Delegated Report

Householder Planning Application

Planning Application No:	20230117
Location:	112 Barr Road, Gravesend, Kent, DA12 4DZ
Description:	Construction of a new vehicle crossover, together with engineering works to create a driveway and a retaining wall
Applicant:	Mr Simranjeet Singh Sond
Site Visit Date:	Desktop assessment

Proposed site block plan

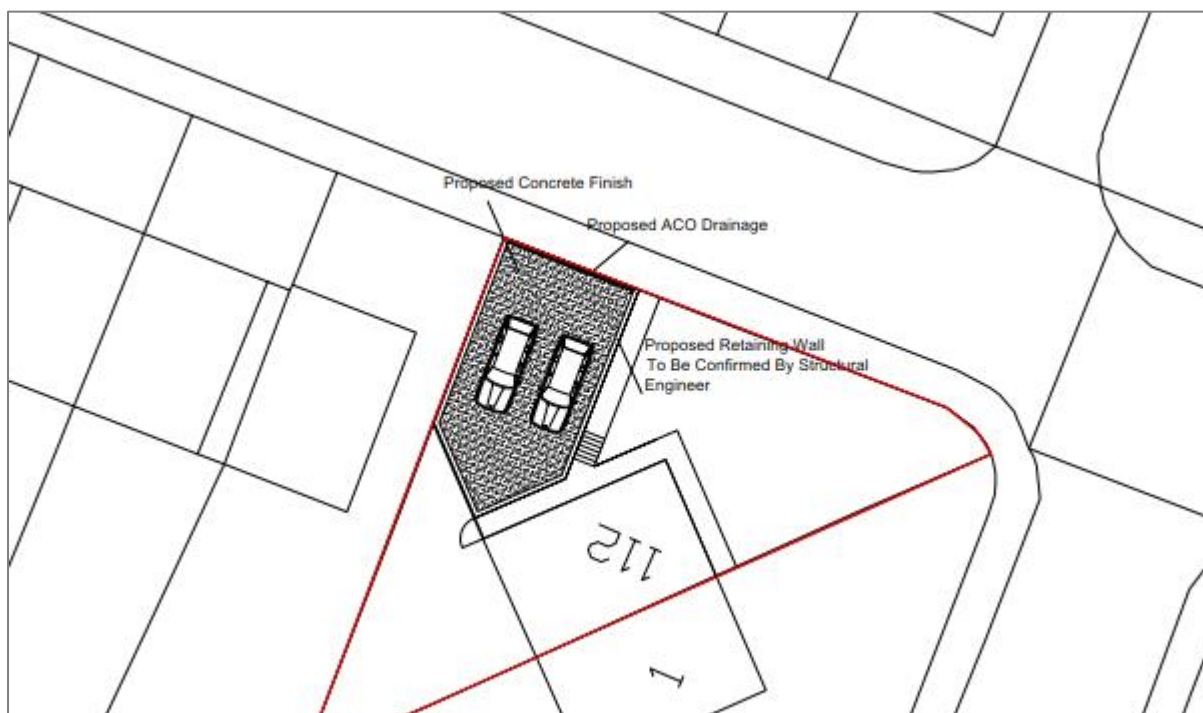
- 1) The enforcement team have referred to the steps moving, but if these move then the retaining wall also needs to be relocated as the pedestrian access will presumably be at the same level as the driveway. If the steps remain in their original position, then the wall should be correct.
- 2) Drainage is shown to be via a ACO Drainage Channel, this however needs to drain to a soakaway, given a soakaway cannot be within 5 metres of a road or a building, (Building Regulations). Bound permeable paving would be a more appropriate choice but failing that a drainage plan should be submitted.

It initially appeared from the proposed plans that the position of the existing steps was changing; however, the agent has confirmed that this is not the case, and the steps will stay as they are.

Drainage is shown to be via a ACO Drainage Channel. However, this would need to drain to a soakaway, and given that a soakaway cannot be within 5 metres of a road or a building (Building Regulations) a bound, permeable paving would be a more appropriate choice. Failing this, a drainage plan should be submitted.

To protect pedestrian visibility splays, no boundary treatment, hard or soft landscaping within 2 metres of the back edge of footway should exceed 1 metre and ideally 850mm height above the footway within 2 metres of the edge of the driveway.
